PAPER MACHINERY CORPORATION

BOTTOM FINISH/LID GROOVE STATION

No. 235.1

NEW CAM PMC-1002

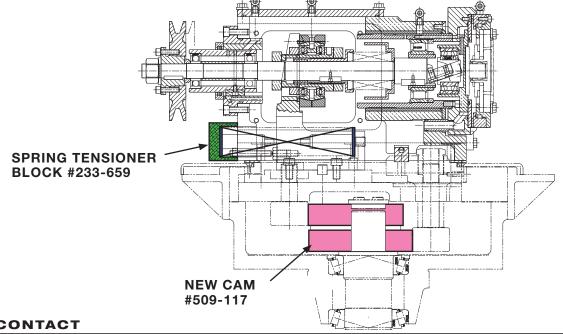
Paper Machinery Corporation has redesigned and successfully completed field testing of a new Bottom Finish/Lid Groove Station Cam with increased life of cam and followers.

This Cam is being offered as a direct replacement for the now obsolete Cam #403-760. For first time replacement, a new Spring Tensioner Block is required.

Tensioner Block is required to decrease existing spring pressures and does not need replacement thereafter.

To purchase this assembly, use part #827-595 which includes new Cam #509-117 and Tensioner Block #233-659.

PMC recommends changing Springs and Cam Followers. (Ref: SP-12962 [x2], BR-15055 [x1], BR-15200 [x1])
